# ***Value Engineering Study Report***

## ***SR 8/US 78 at Mann Road/Mason Creek Road and at Post Road Intersection Improvements, Douglas County CSSFT-0008-00(375), PI No. 0008375***

***February 2012***

Subject: Final Value Engineering Study Report  
***SR 8/US 78 at Mann Road/Mason Creek Road and at Post Road  
Intersection Improvements, Douglas County, CSSFT-0008-00(375)  
PI No. 0008375***

**VE ALTERNATIVE A-10**

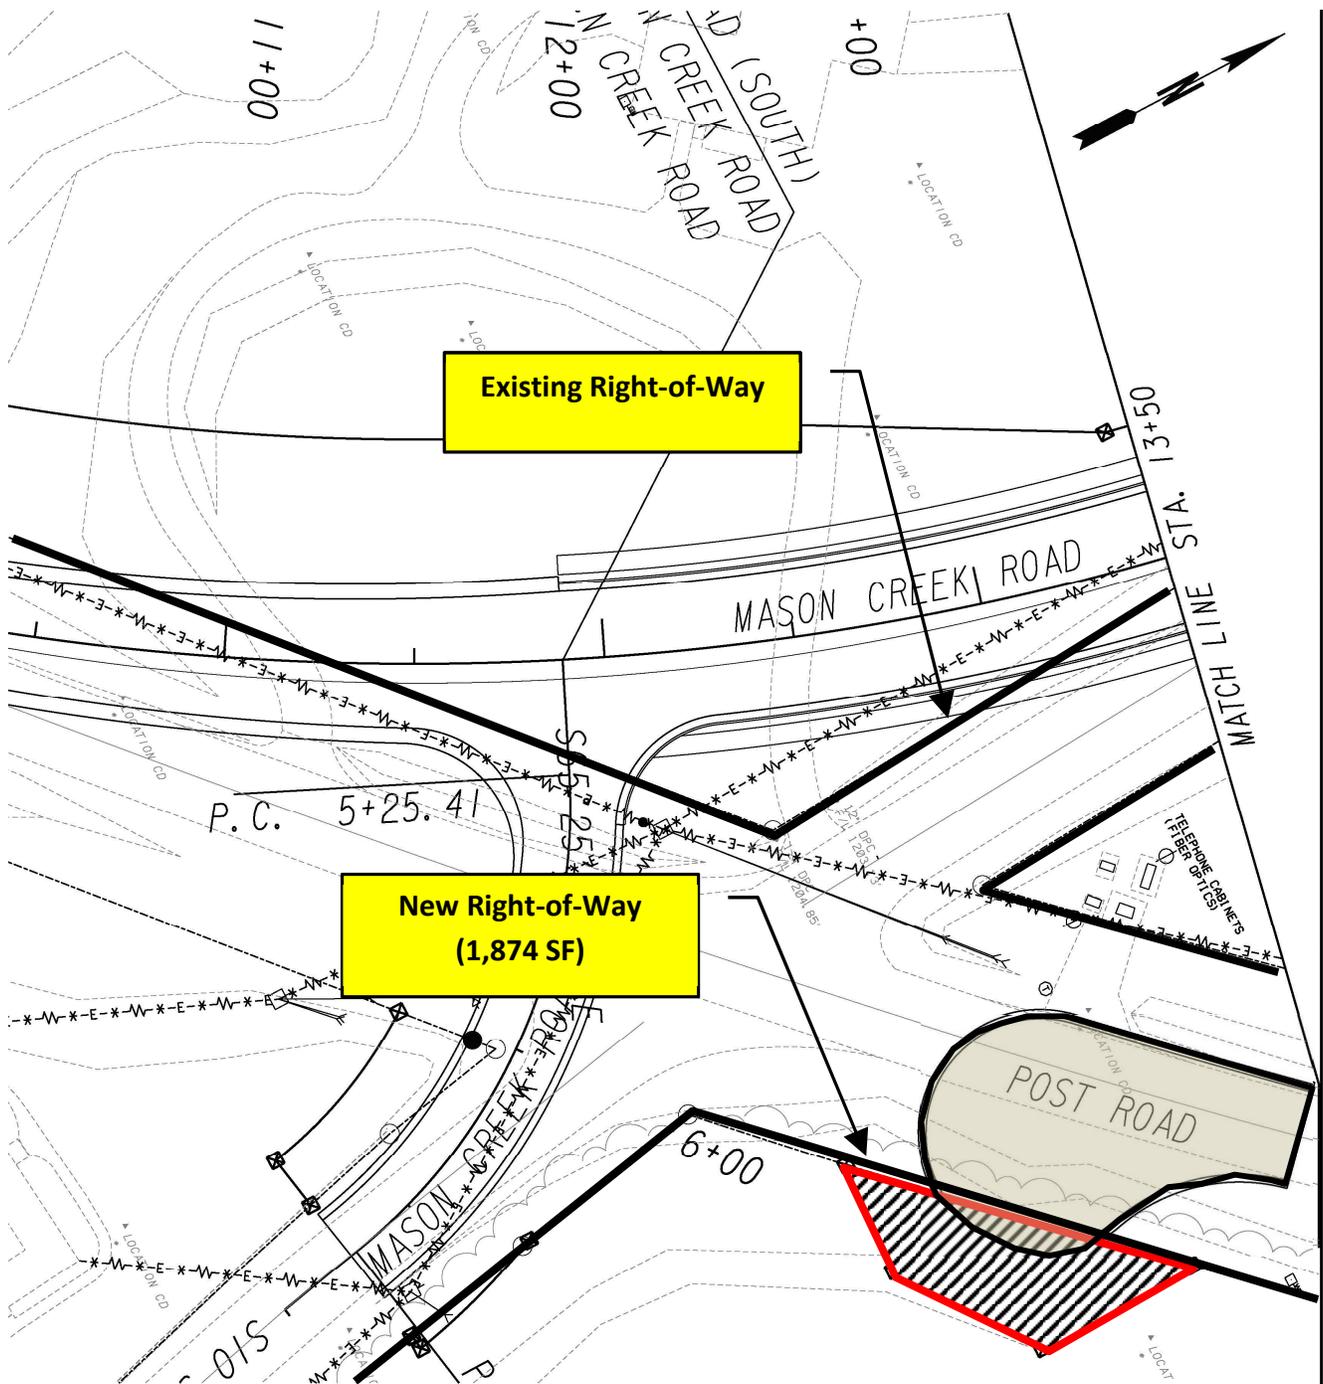
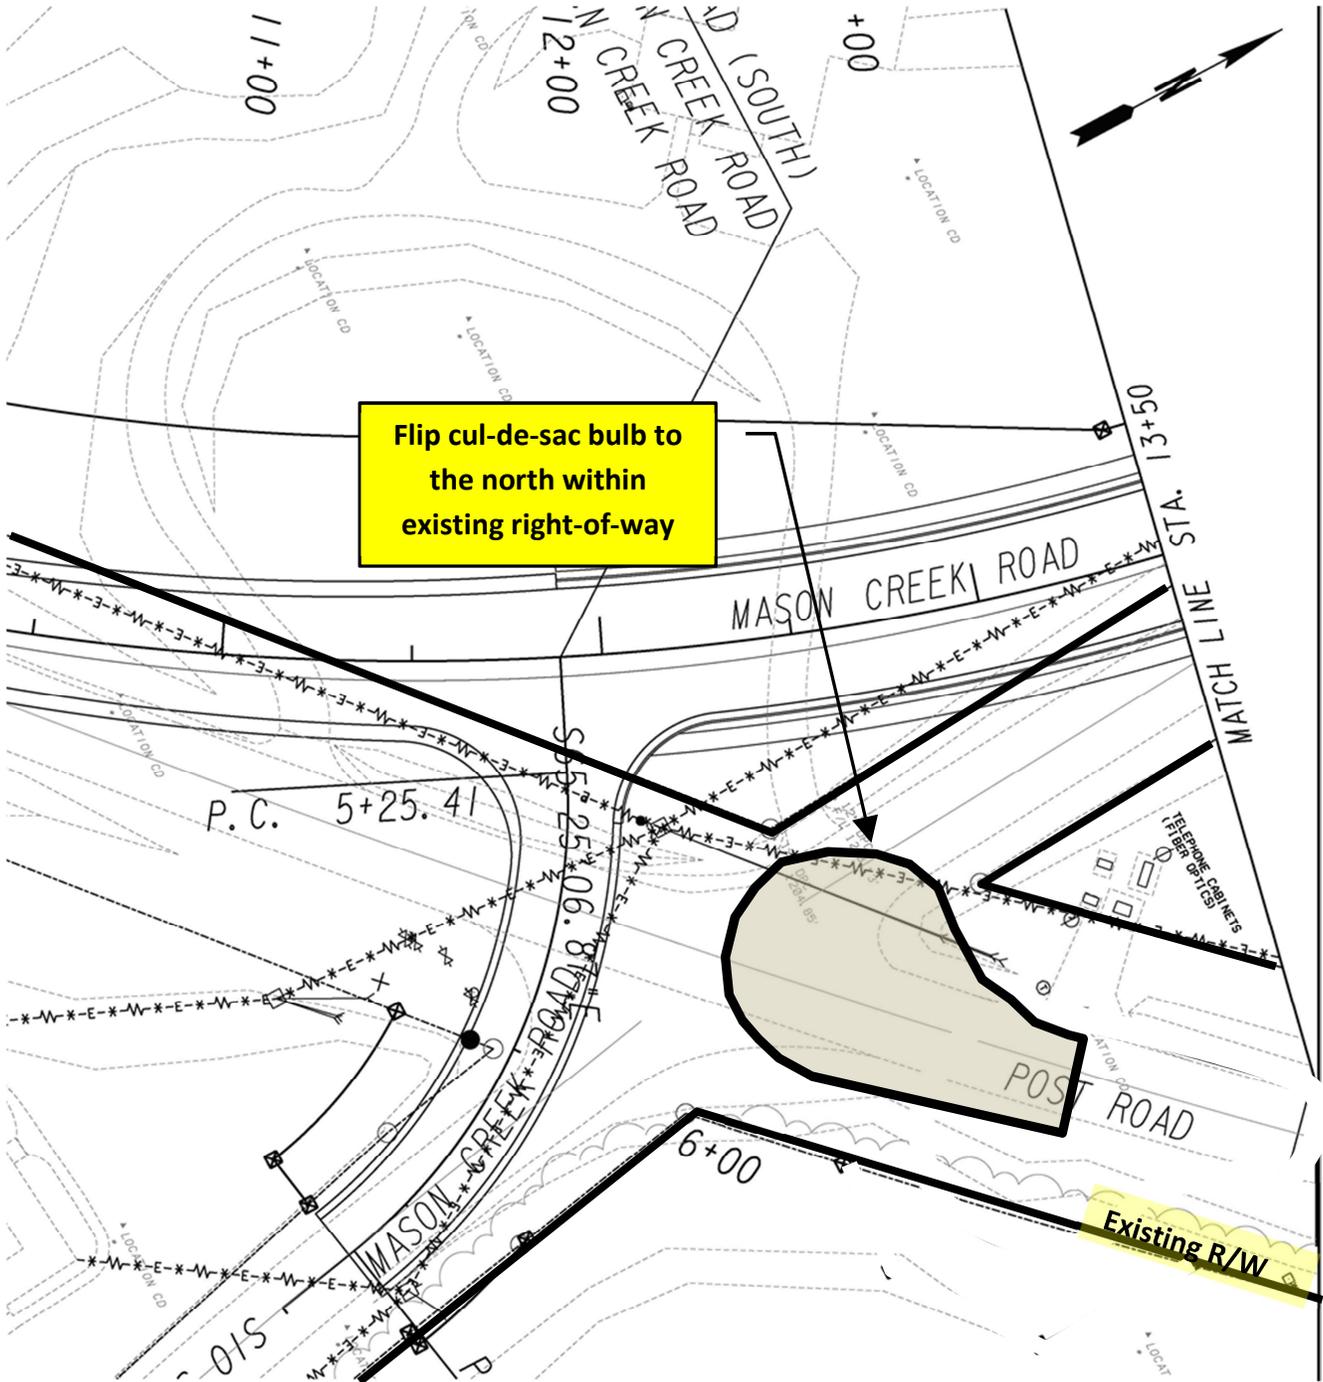
**Discussion:** This change results in a modest cost reduction, but performs the same function as the baseline concept at a slightly lower cost; however, the primary goal of this alternative is to reduce the administrative and legal implications involved with any right-of-way transaction.

Move the cul-de-sac further south on Post Road and flip the bulb to the north side to take advantage of existing right-of-way

# VE ALTERNATIVE P-1

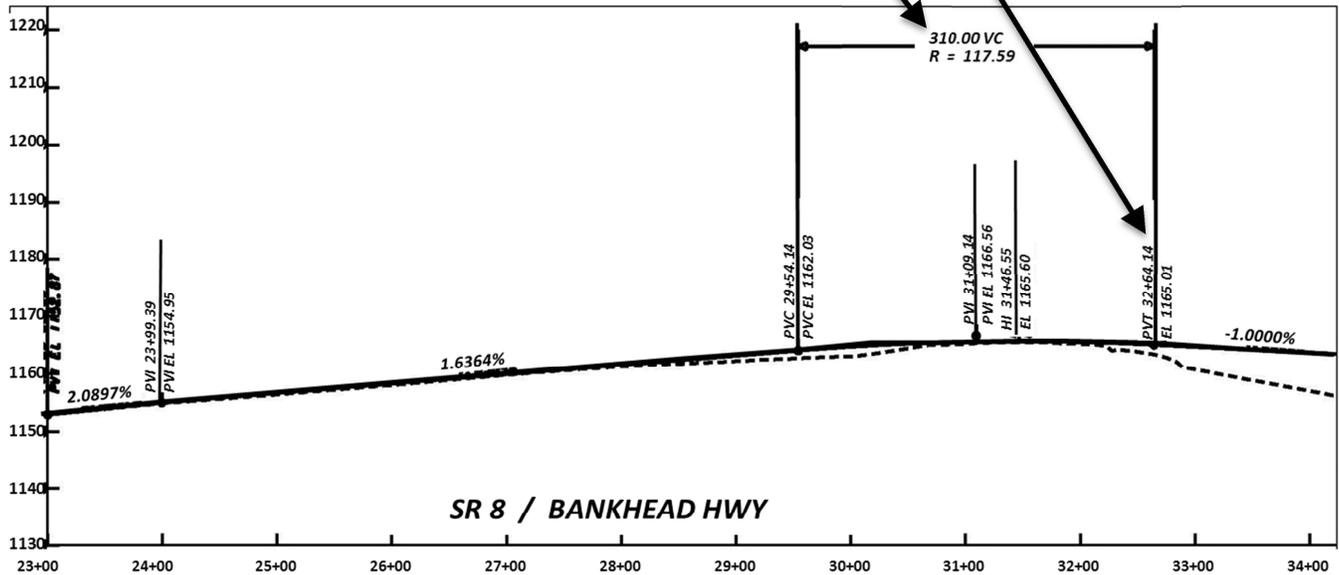
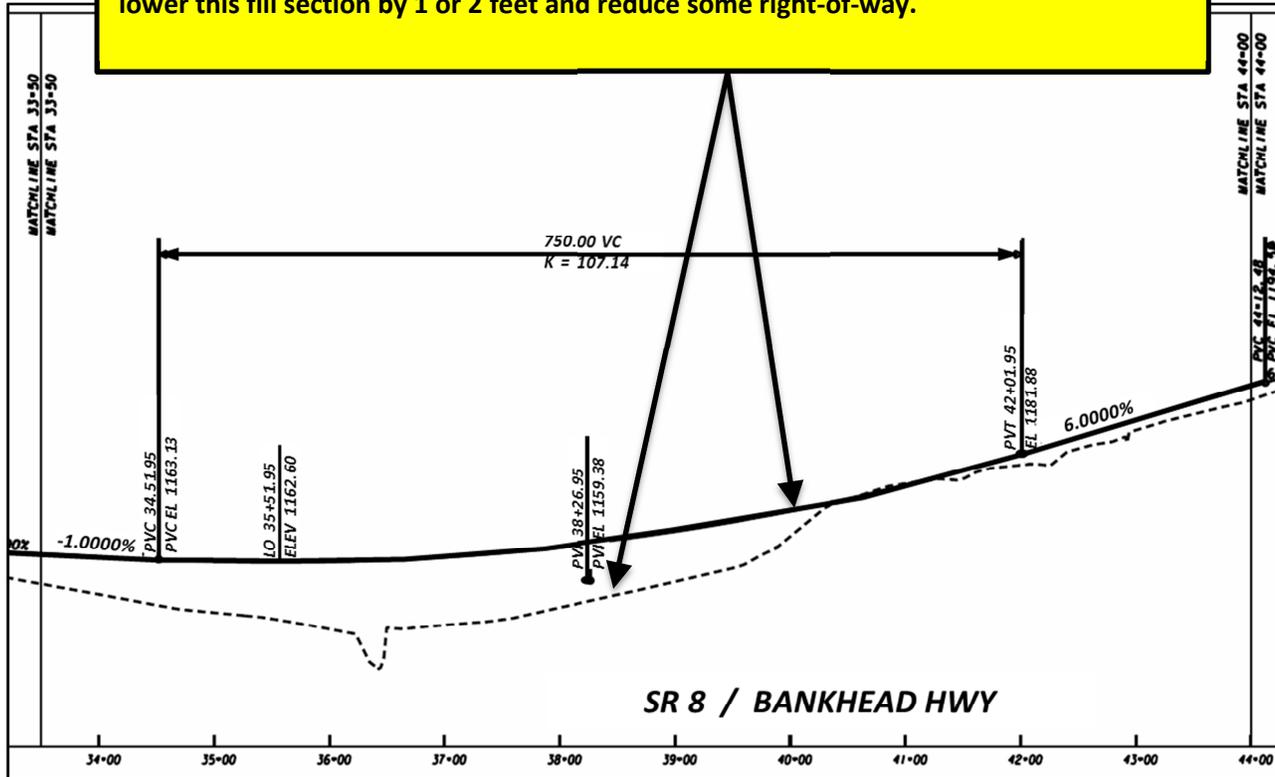
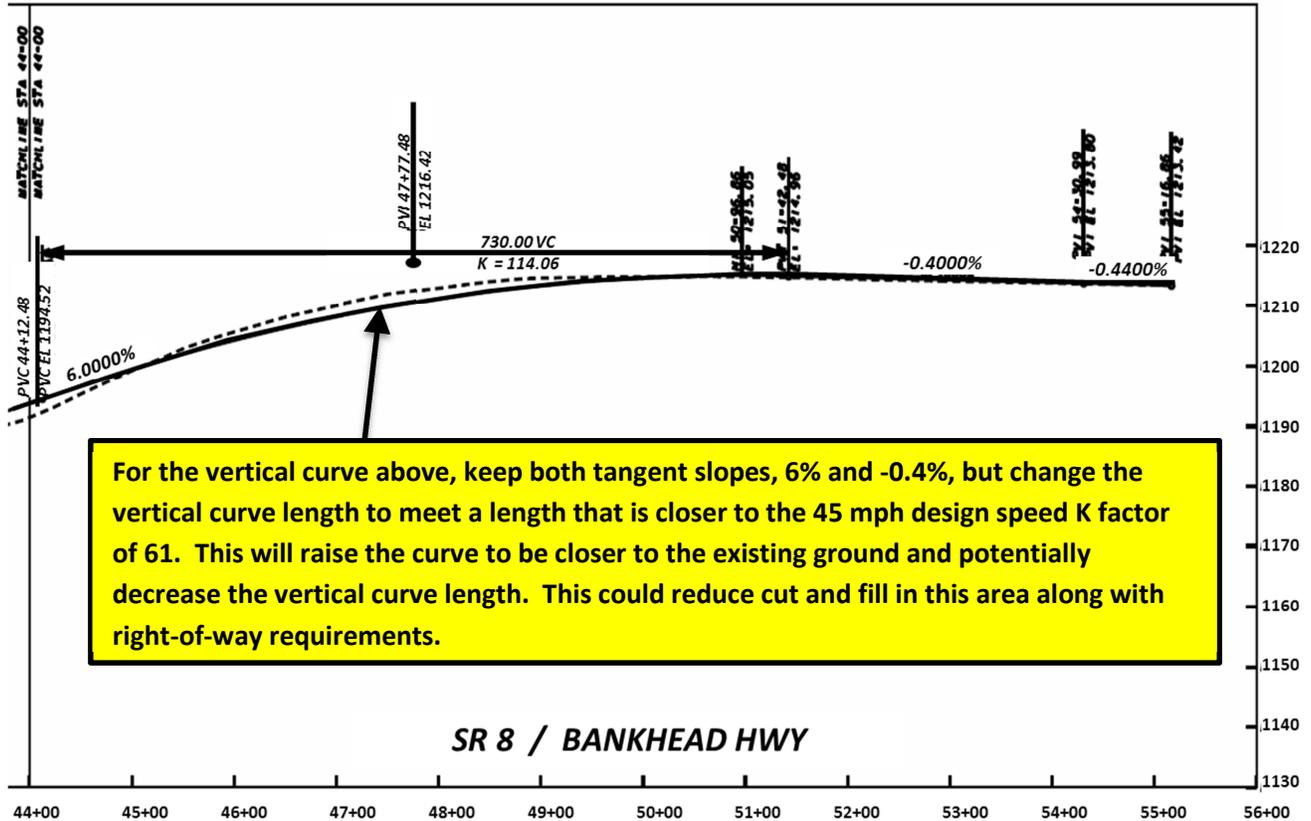
**Discussion:** Since the project’s design speed was changed to 45 mph, the horizontal alignment was analyzed to see if the alignment could be placed back over the existing alignment. Seeing that the vertical curve over the major culvert would still not meet the existing grade for some distance and considering time needed to redesign the horizontal for accuracy, the alternative kept the horizontal alignment at its proposed location, but modified the vertical profile to closer meet the 45 mph design criteria. The first curve at this new design speed was able to tighten up the curve length. The second curve was able to modify the 1% slope, adjust the PVI and then tighten its vertical curve. The second curve kept both slopes as they were, but tightened the vertical curve to match the existing roadway. This seems to direct attention to looking at shifting the alignment for a short distance back over the

For this curve, modify the curve data for any adjustments needed for the 1% slope change. Keep the 1.6364% grade. Adjust the vertical curve length as needed and that meets design criteria for a 45 mph design speed. Keep the VPI at its current location.

For the vertical curve below, consider dropping the 1% tangent slope some as mentioned before and keep the 6% slope afterwards to potentially decrease the vertical curve length. The VPI may need adjusting to accommodate an adequate vertical curve length to meet the 45 mph design speed. With this combination of changes, this could lower this fill section by 1 or 2 feet and reduce some right-of-way.

Revise the profile and alignment on Bankhead Highway to account for a 45 mph design speed in lieu of the 55 mph design speed
